Owner Occupied and Scattered Site Rehabilitation Programs

**Addendum # 2
November 17, 2015**

Project # 1007 Property Address: 16 Chetwood Street, Milford, CT

BUILDING UTILITY PLAN

JOB NO.	DRAWING NUMBER	SHEET
33-262-1007	BASEMAP 33-262-1007.dwg	C-1.3

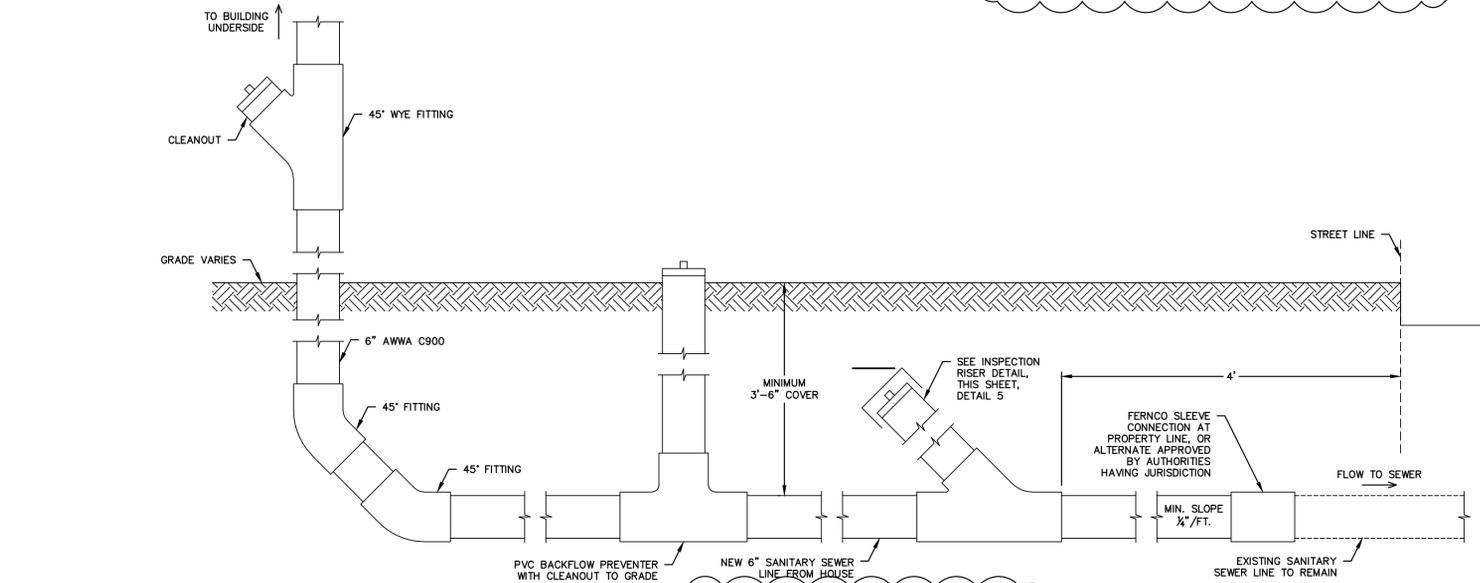
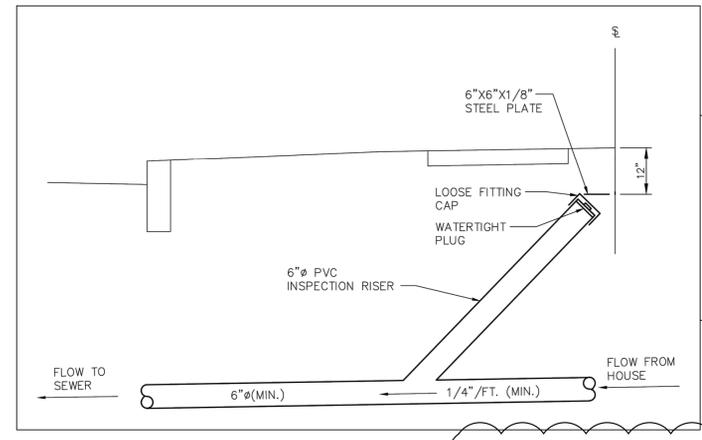
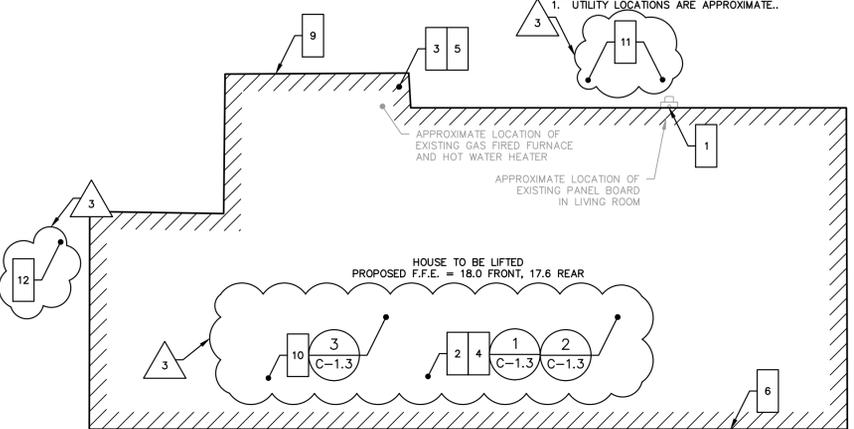
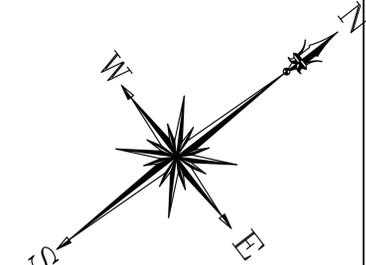
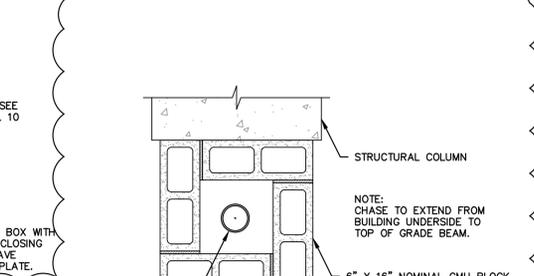
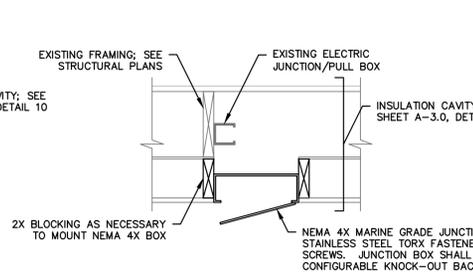
1. Drawing sheet Building Utility Plan – C-1.3 to be replaced with attached sheets, drawing revisions are noted and dated 11-17-2015 – Bid Addendum 2. See Attachment 1 for changes made to drawing sheet C-1.3
